# Port Master Plan Update Project

Final Program Environmental Impact Report (Volume 1 of 4)

December 2023

## **Attachments to Chapter 2, *Comment Received and District Responses*, Pertaining to District Responses**

PD3.43 Along Pacific Highway, the following standards apply, as generally depicted in Figure PD3.8 and Figure PD3.9:

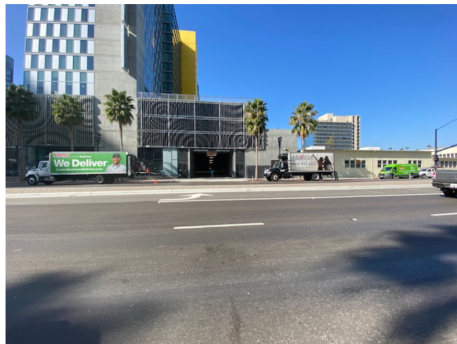
Change Figure PD3.9 and Figure PD3.8: For new construction

- The Pacific Highway base building frontage shall be a ~~minimum of 45~~ maximum height of 30 feet parallel to Pacific Highway.
- The Pacific Highway base building structure may shall be a maximum height of 65 30 feet, to comply with the City of San Diego Fire Department requirements. Above ~~50~~ 30 feet, the tower building shall step back 45- 25 feet. (Fire Department requirements can be met on east-west streets)
- There is no street wall requirement, or required maximum distance from the setback.

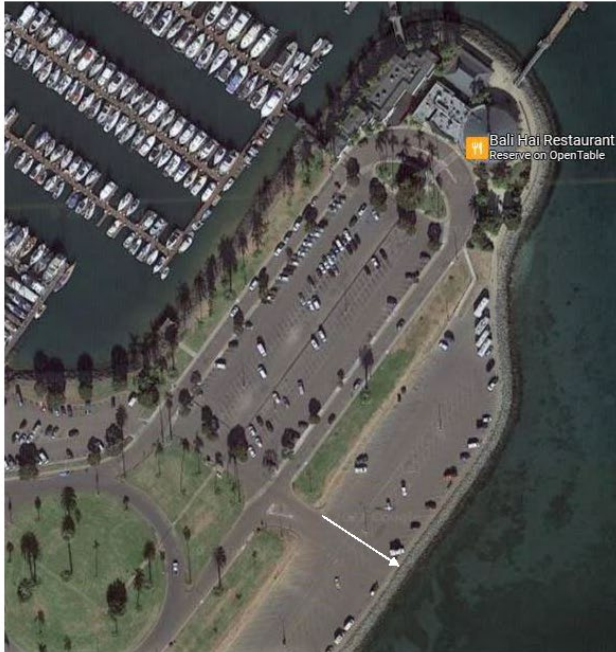
This is the section of the lower parking lot for a proposed cross over pedestrian path.
